Office Action Summary	Application No. 10/614,772	Applicant(s) PLATTS, DAVID A.	
	Examiner William H. Rodriguez	Art Unit 3746

DETAILED ACTION

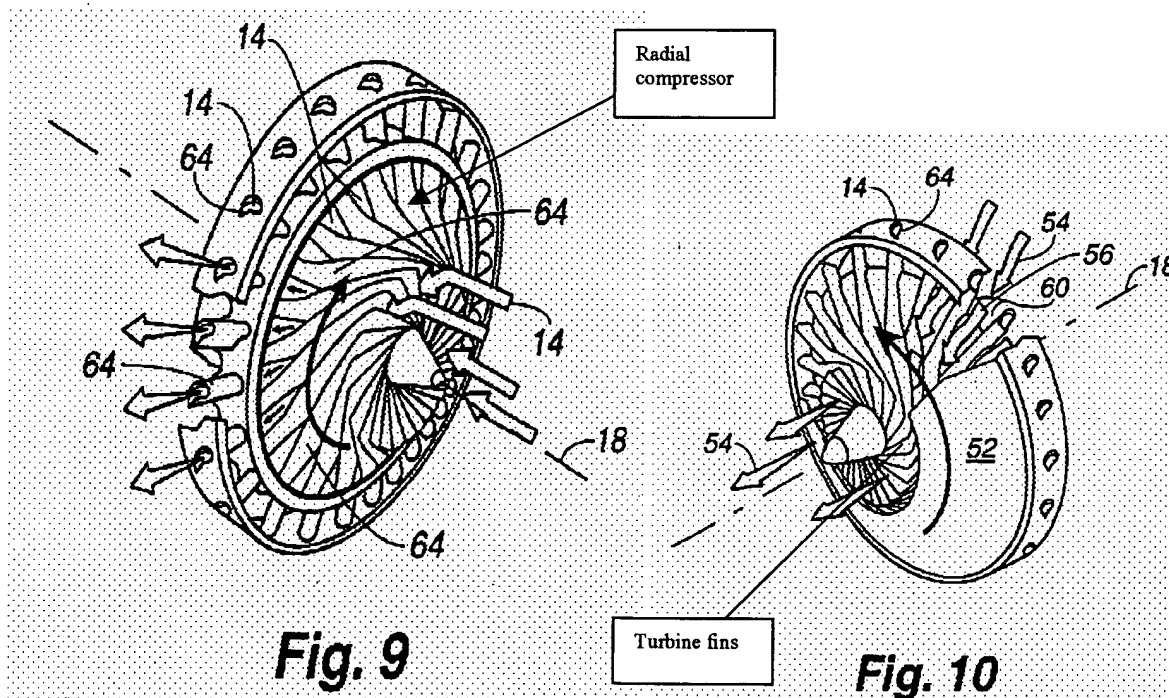
With respect to claim 1, **Platts** teaches a rotor for use in turbine applications comprising: a radial compressor having radially disposed spaced apart fins 64 forming passages, and a radial turbine having hollow turbine blades 60 interleaved with said fins and through which fluid from said radial compressor flows. See particularly **Figures 9 and 10** of **Platts** above.

With respect to claim 2, **Platts** teaches that the rotor further comprises spaced apart turbine fins for receiving said fluid. See particularly **Figures 9 and 10** of **Platts** above.

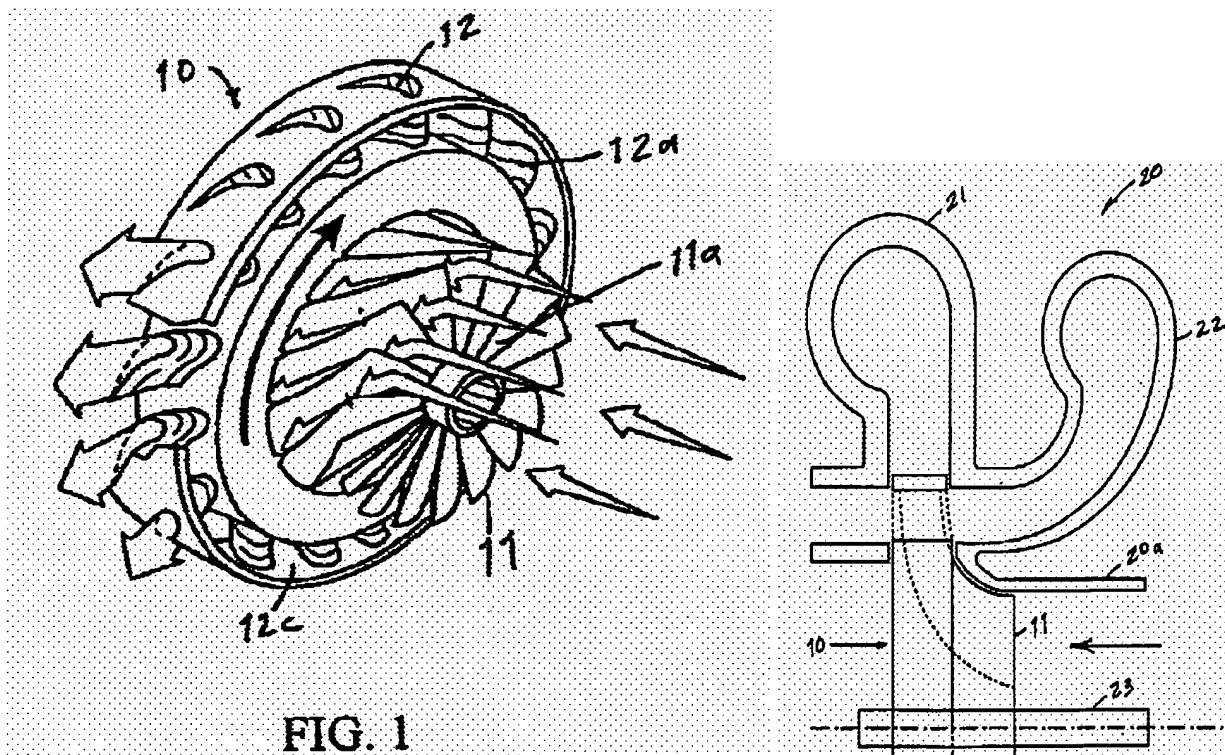
With respect to claim 1, **Platts** teaches a rotor for use in turbine applications comprising: a radial compressor 11 having radially disposed spaced apart fins 11a forming passages, and a

radial turbine having hollow turbine blades 12a interleaved with said fins and through which fluid from said radial compressor flows. See particularly **Figures 1, 2 and 4** of Platts.

With respect to claim 3, **Platts** teaches rotor is located by a shaft inside a turbine engine housing 20 defining a compressor outlet volute 21 and a turbine inlet scroll 22, wherein said radial compressor compresses air into said compressor outlet volute and heated exhaust air is directed through said hollow radial turbine blades from said turbine inlet scroll, causing said rotor to rotate. See particularly **Figure 4** of Platts.

With respect to claim 4, **Platts** teaches a turbine engine comprising: a turbine engine housing 20, said turbine engine housing having a compressor outlet volute 21 and a turbine inlet scroll 22, a single rotor 10 mounted to a shaft inside said turbine engine housing, said rotor having a radial compressor 11 with axially disposed spaced apart fins 11a forming passages, and an radial turbine having hollow radial turbine blades 12a interleaved with said fins and through which air from said radial compressor flows; wherein said radial compressor compresses fluid into said compressor outlet volute and heated exhaust fluid is directed through said hollow radial turbine blades from said turbine inlet scroll, causing said rotor to rotate. See particularly **Figures 1, 2 and 4** of Platts.
